ADDENDUM

Addendum #01

RE: Renovate 4E NMAL Office Suite

Smithsonian Facilities Project No. 2466904 Ayers/Saint/Gross Project No. 3000738

PANELBOARD SCHEDULES

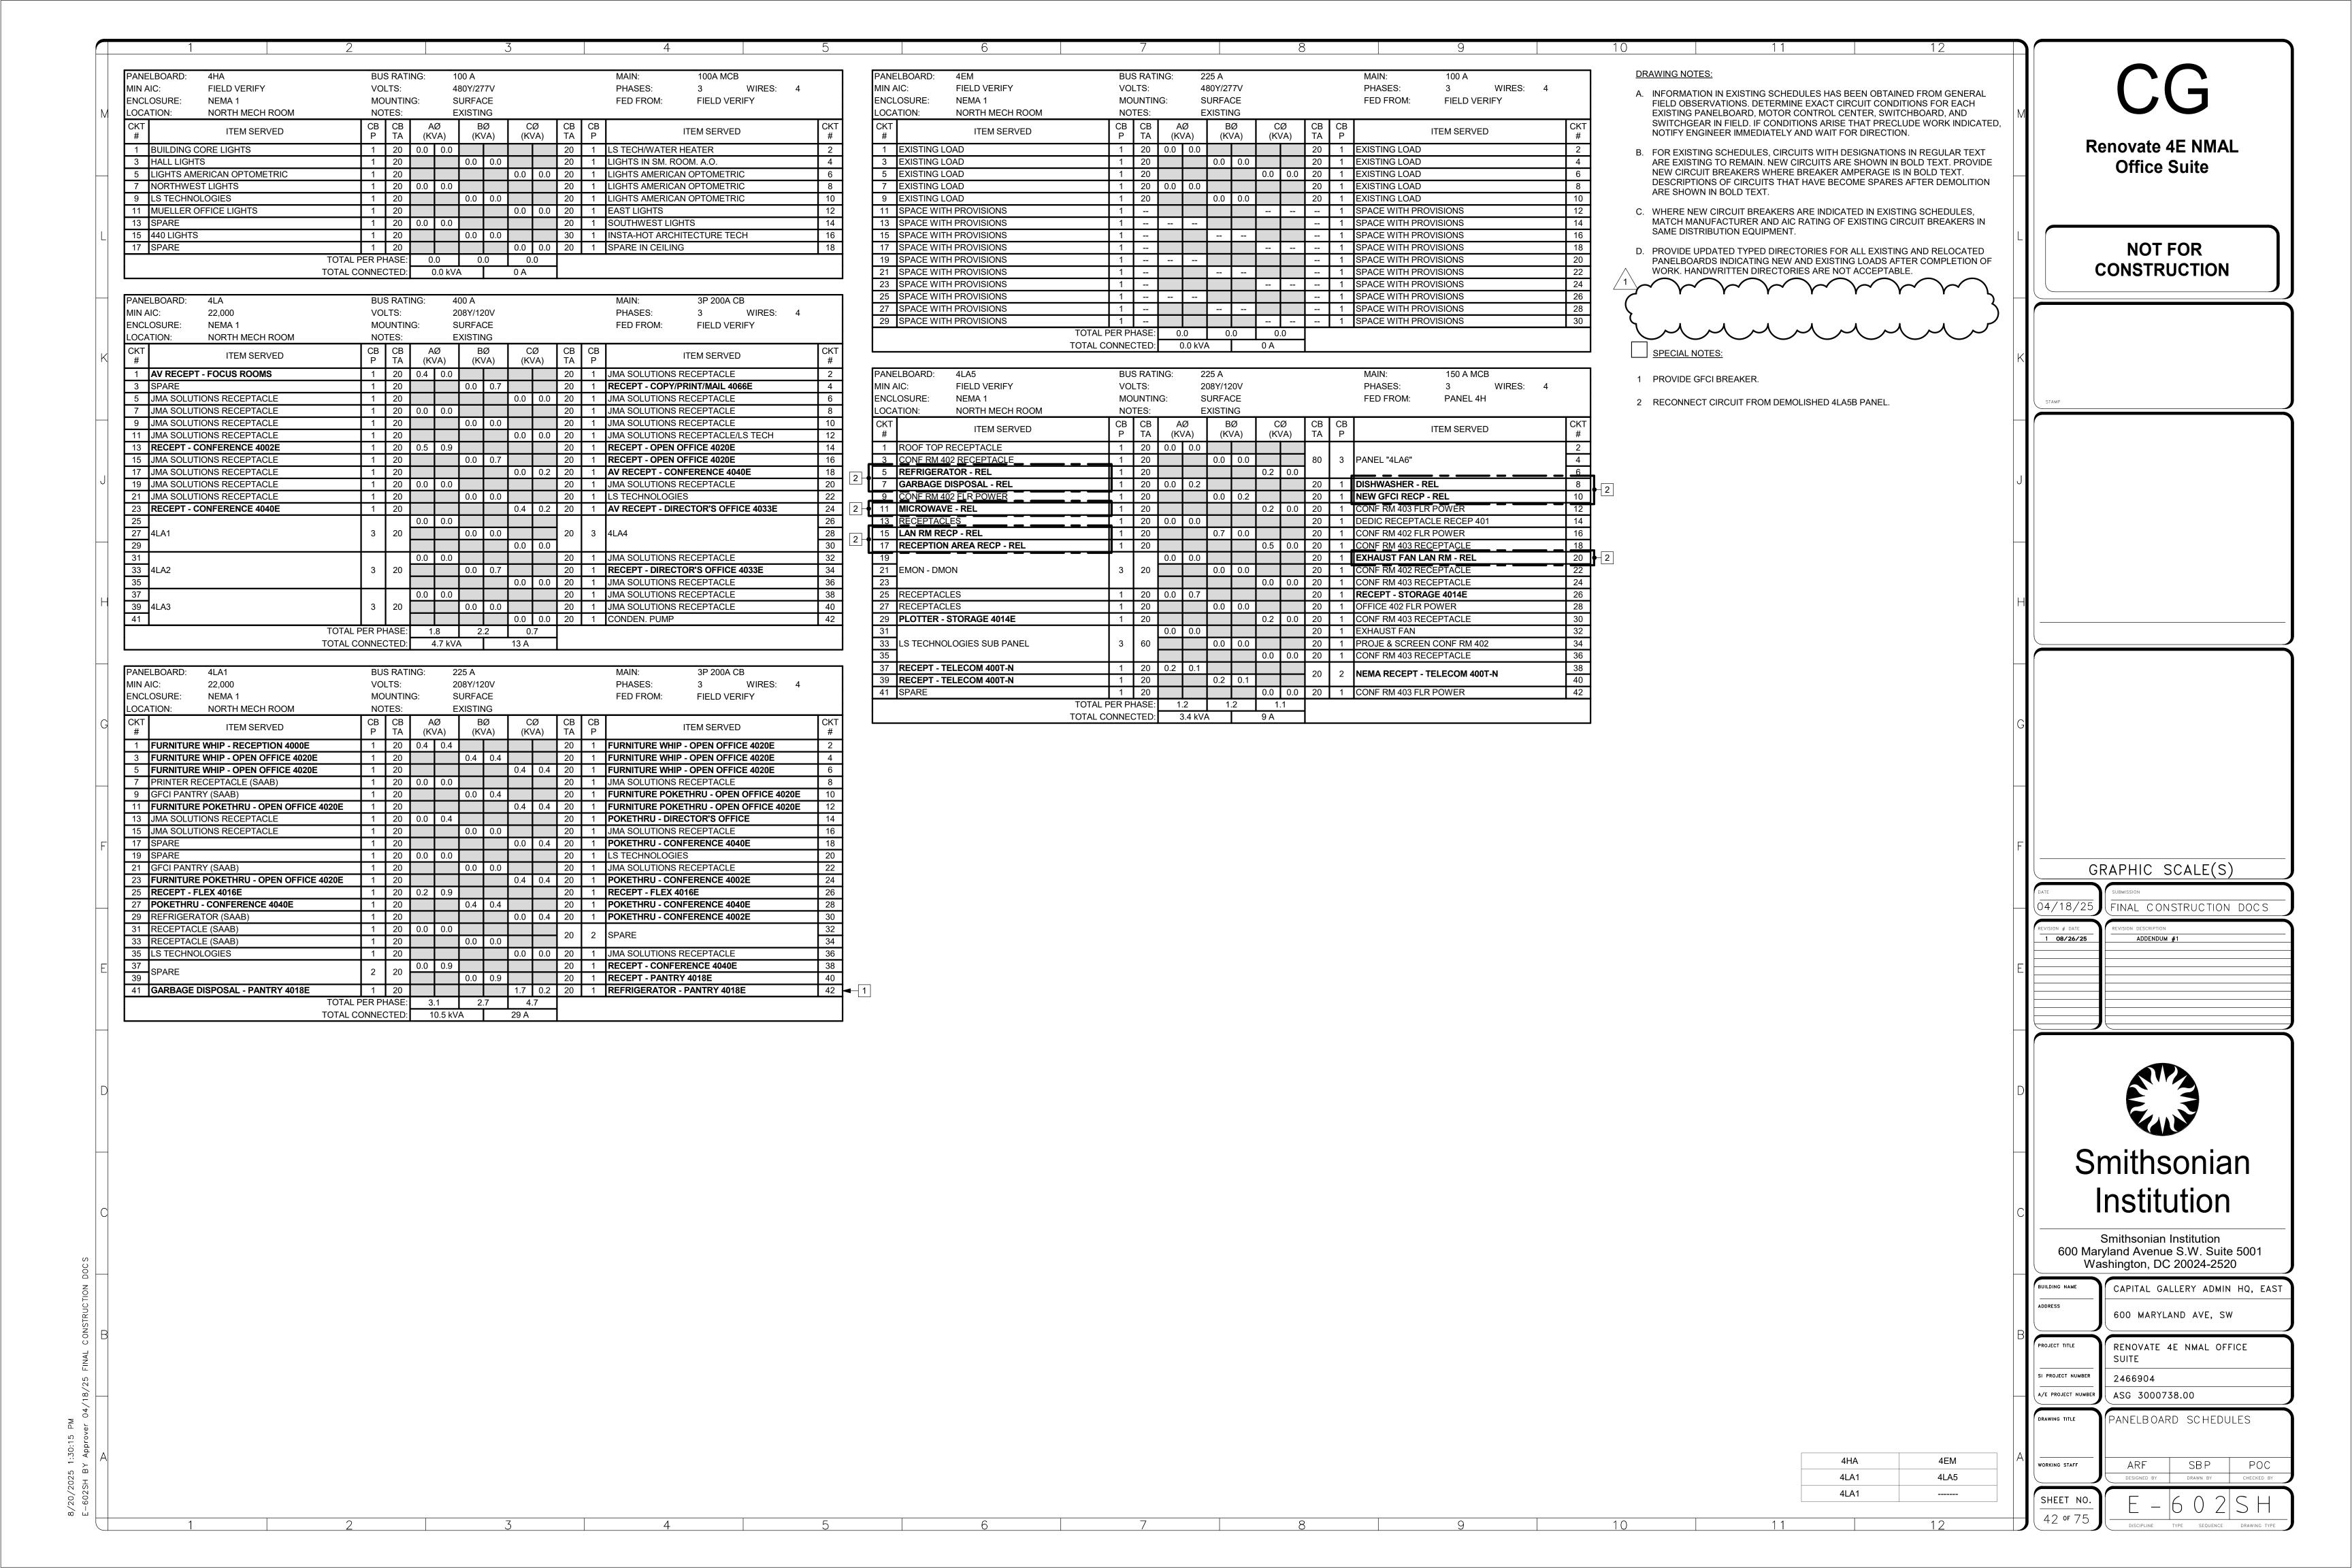
- E-101LP LIGHTING PLAN PARTIAL LEVEL 4 NORTH NEW WORK
 - Updated lighting controls in Storage 4014E to be timer switches
- E-501DT ELECTRICAL DETAILS
 - Removed controlled receptacle from Detail 4.
- E-601SH ELECTRICAL SCHEDULES
 - Added Lighting Control Intent Schedule and associate notes.
- E-602SH PANELBOARD SCHEDULES
 - Removed note about new panels
- E-603SH PANELBOARD SCHEDULES
 - Removed note about new panels
- E-902SS ELECTIRCAL SPECIFICATIONS
 - Removed specification language on bonding jumpers.
